# **Arlington Conservation Commission**

Date: Thursday, July 9, 2020

### **Agenda**

Notice of Intent: 869 Massachusetts Ave, Arlington High School MassDEP File #091-0323

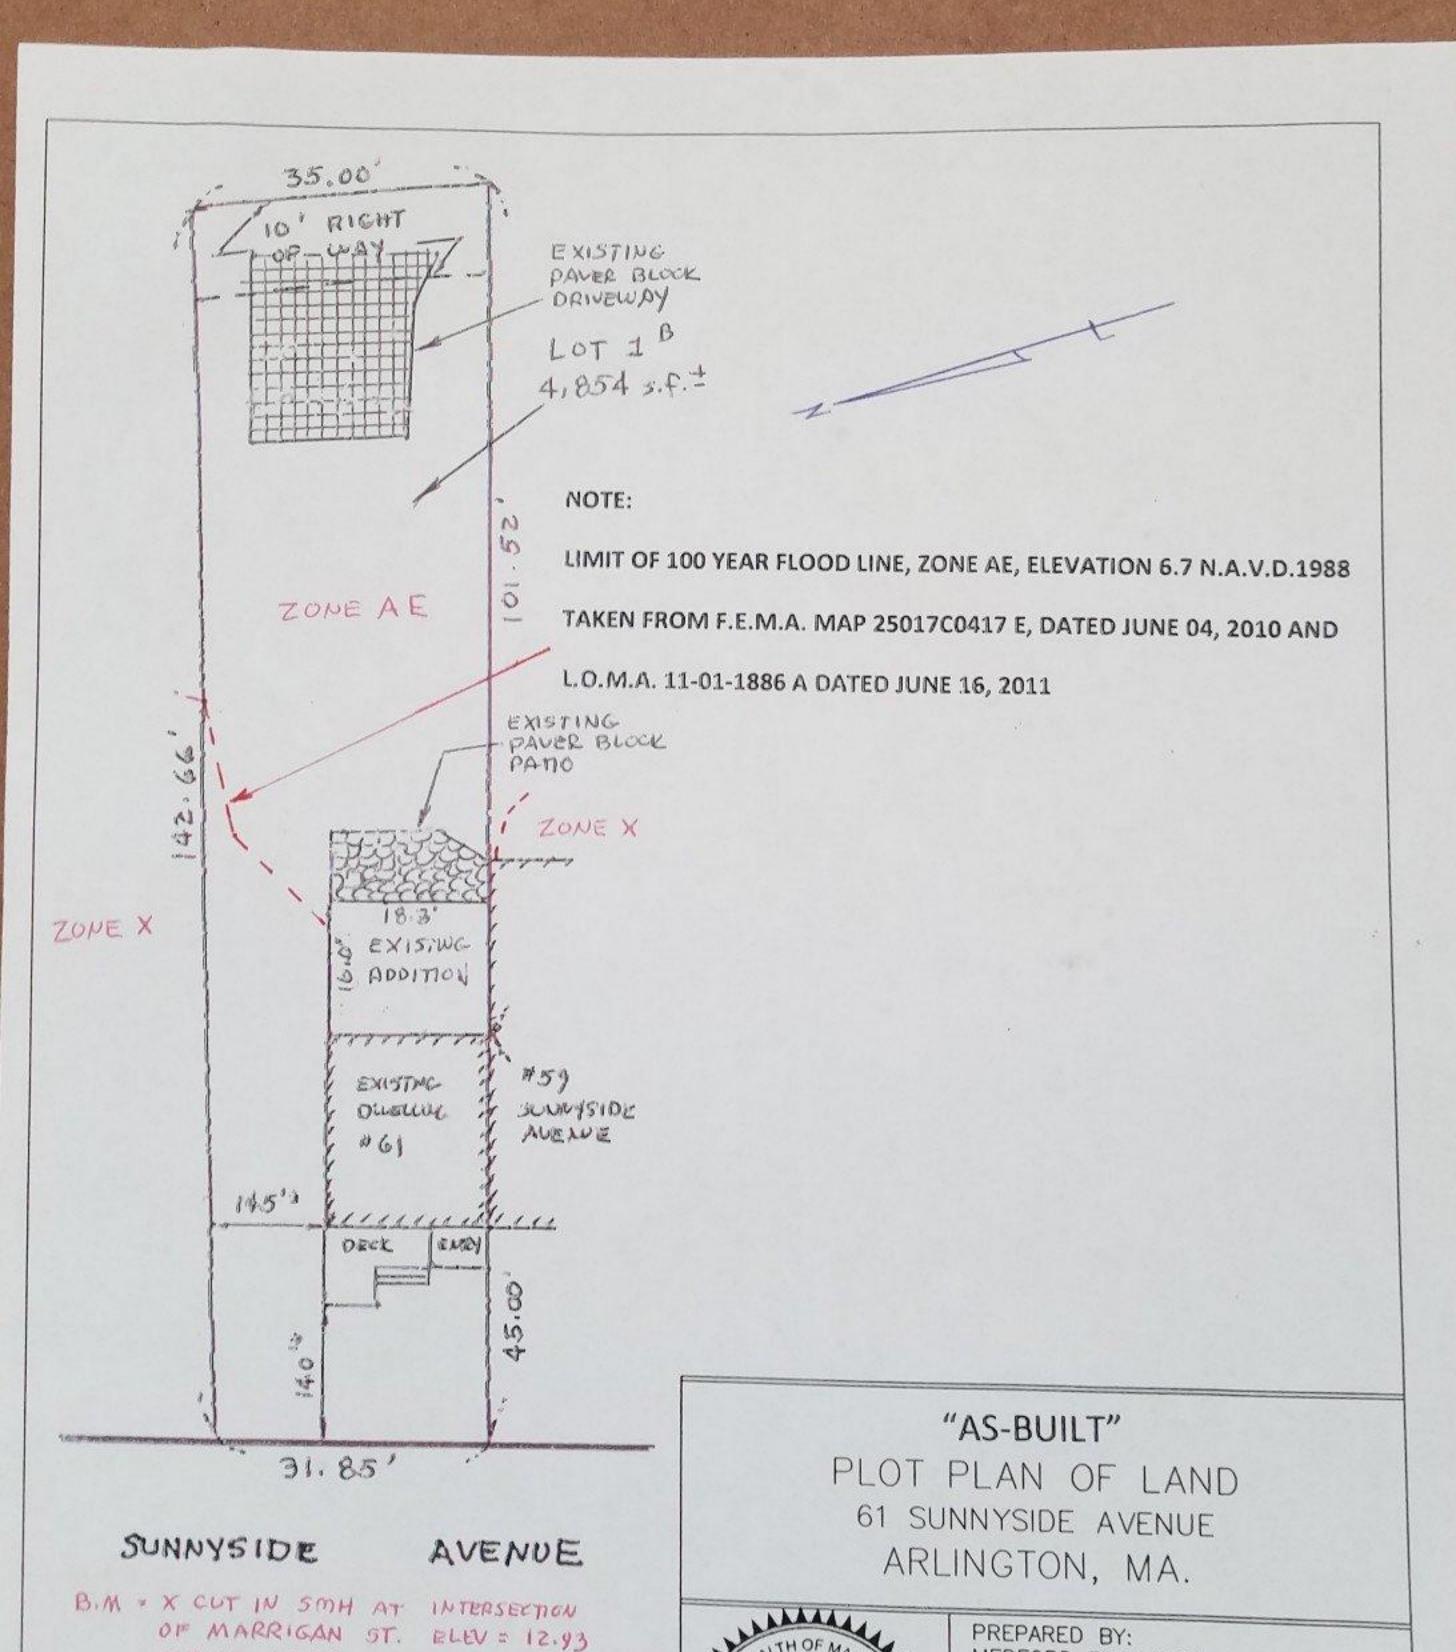
I have completed an as-built of the final construction on 61 Sunnyside Avenue Arlington filed with a Notice of Intent DEP # 091-0311, recorded August 27, 2019 in Middlesex South Registry of Deeds Bk 73174 Pg 547. The construction match's the Notice of Intent Plan by Richard Chadwick & Celia Markey, undated, with the following exceptions.

1) The patio, behind the addition, is larger than proposed.

2) The ground elevation, most likely due to construction, is lower than pre-construction, at the addition and patio, resulting in an increase in the area at or below the 100 year flood elevation.

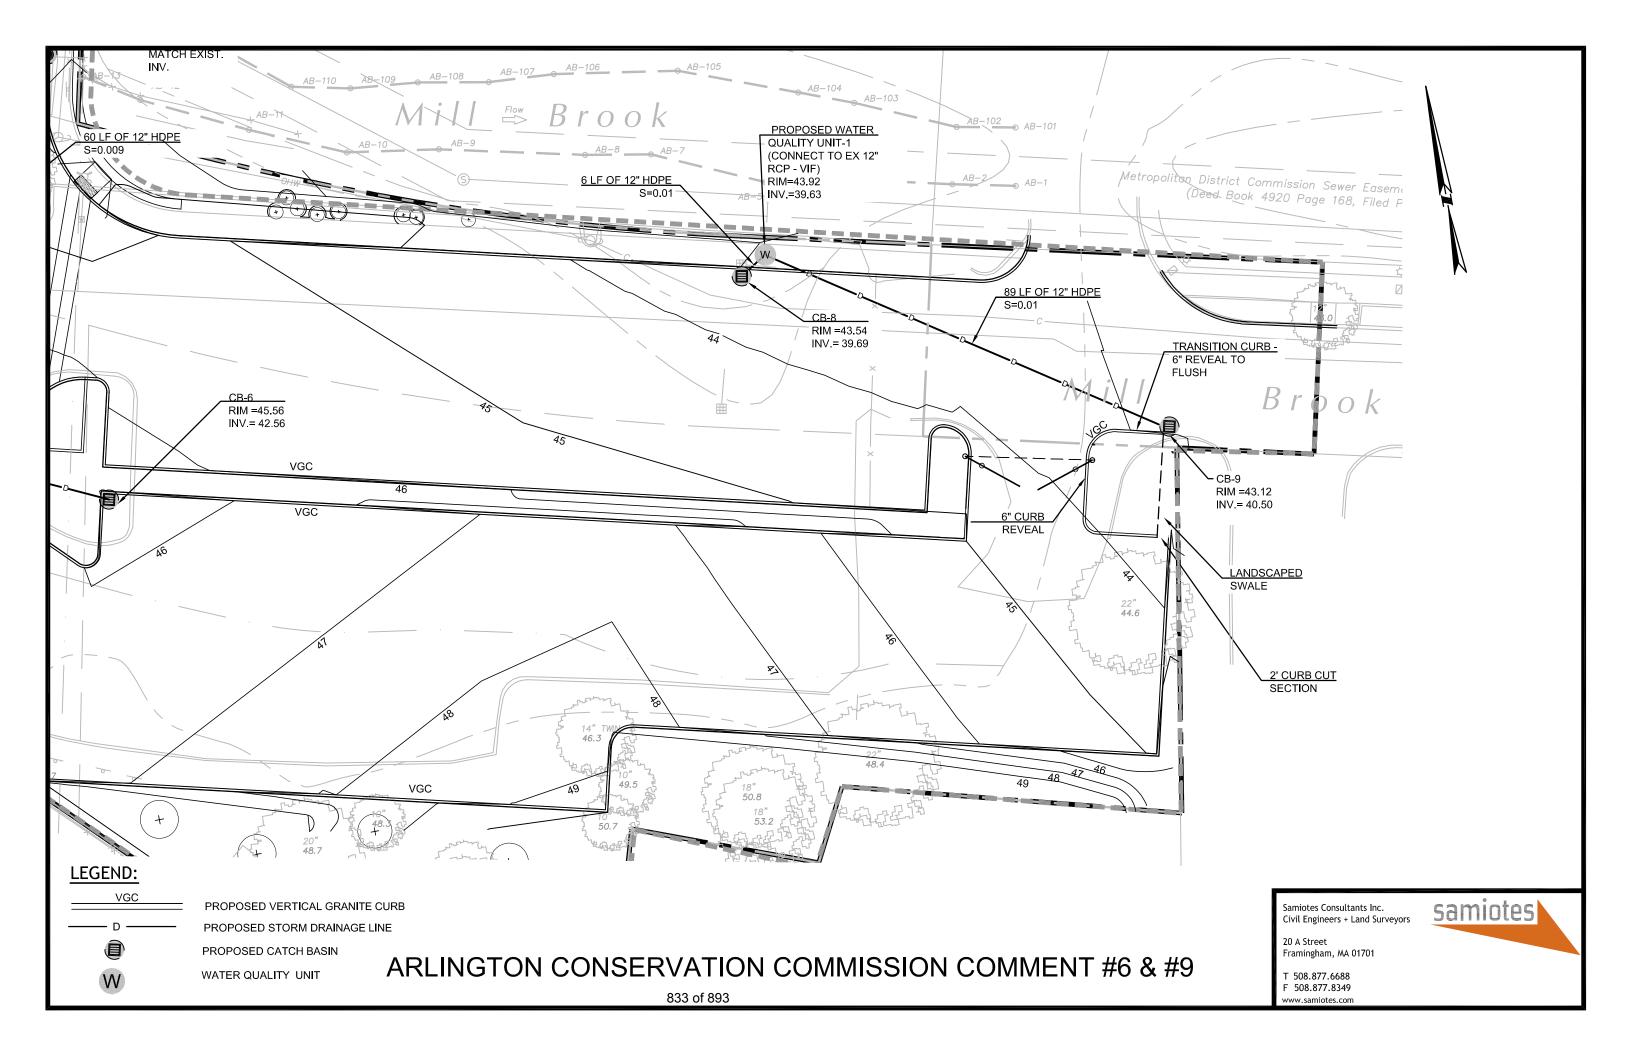
We reviewed the possibility of adding an on-site water capture system to store stormwater for use in landscaping irrigation. We agree with the Commission that this would be a good element for the project, as we always look to add this sort of LID element to our designs. However, there are a number of issues with this strategy for this site, and it was originally part of the project before being determined to be cost prohibitive by the project team due to the cost implications of installation on this site versus value added.

As the Commission knows, this site is located in a highly contaminated soil area. There are very limited areas where installing an underground tank or the lines feeding it and irrigation would not impact the soil contamination and require costly remediation of excavated soils. Those areas would require significant pipe runs to the cistern, and from the cistern to any irrigated areas. The tank would also be buried extremely deeply (approx. 15 feet down) if located outside the contamination area. This cistern was determined to be extremely cost prohibitive early in the MSBA design process.

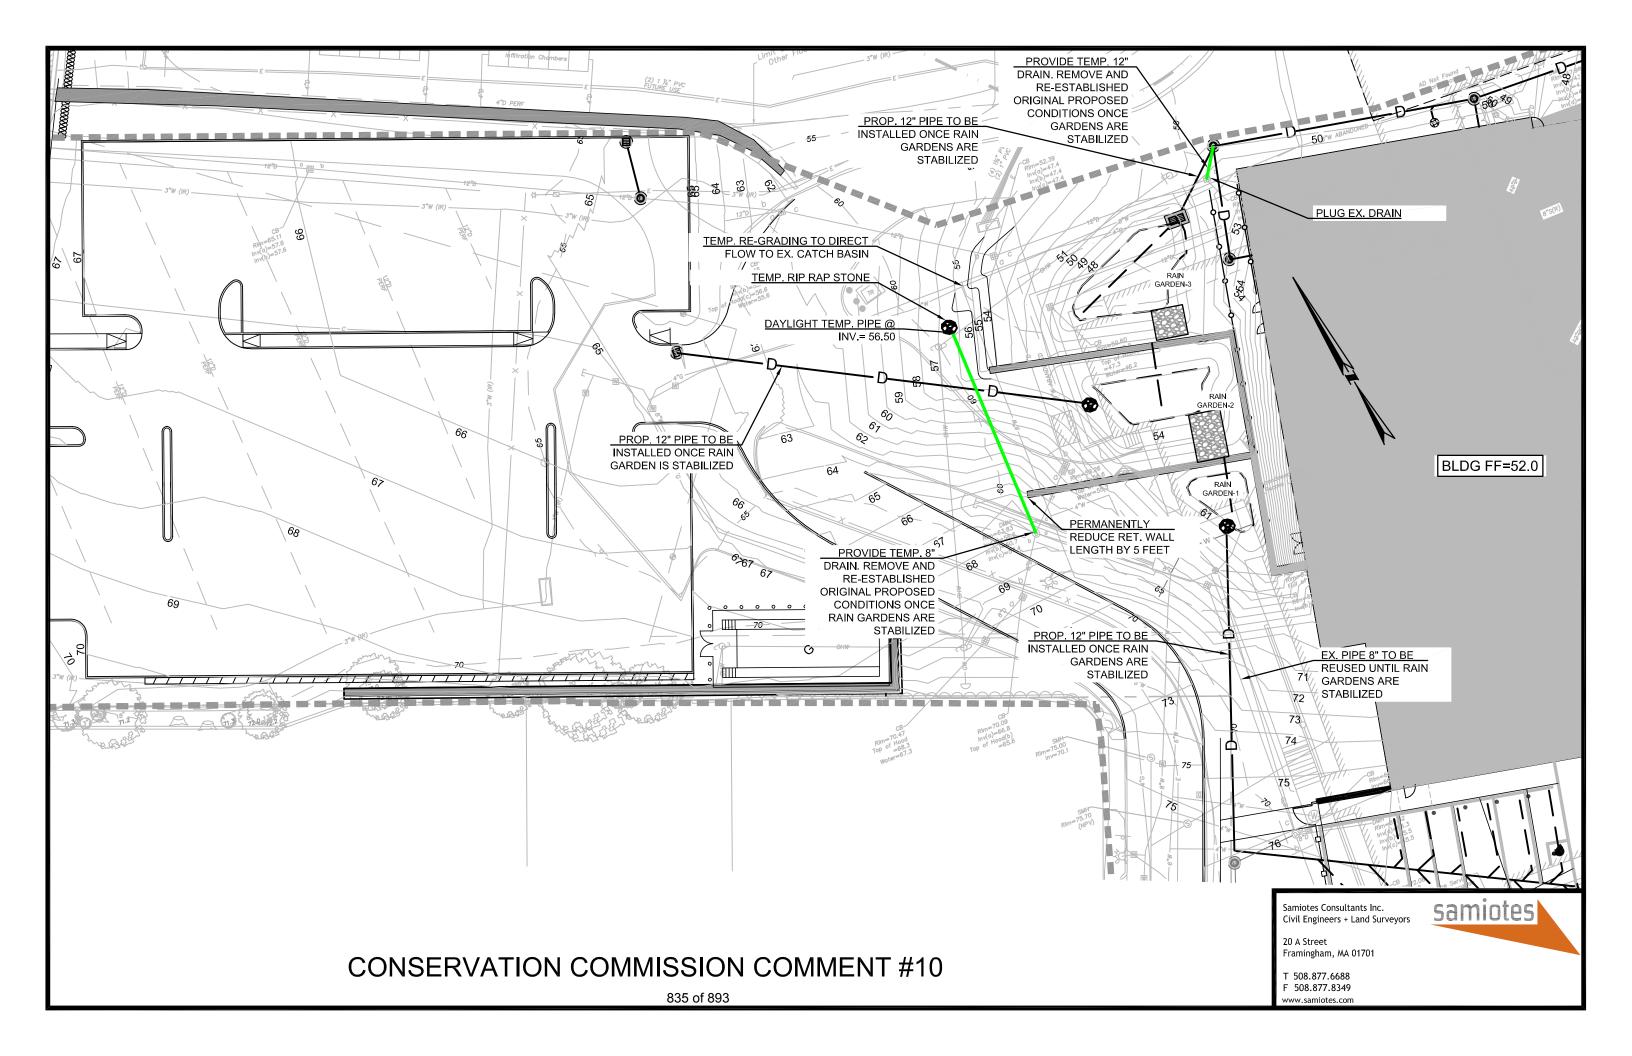
From an engineering perspective, a key portion of the stormwater design for the site includes utilization of an underground stormwater infiltration system, which provides the site with groundwater recharge and water quality treatment in accordance with the requirements of the Massachusetts Stormwater Handbook. If this curbing were to be removed, given the grades in the lower portion of the parking area, a large portion of the tributary area to that underground system that is captured in the gutter on the south side of the parking area and conveyed to the underground system would be lost, and therefore provide less water quality treatment and recharge to groundwater of the parking area. In order to meet the requirements, additional proprietary water quality treatment units would be necessary, which incur additional costs and do not provide the required recharge to groundwater.

Therefore, we are proposing to utilize the landscape island on the far east side of the parking area to send stormwater flows overland through the landscaping prior to discharging to the proposed water quality unit as shown in the sketch provided.
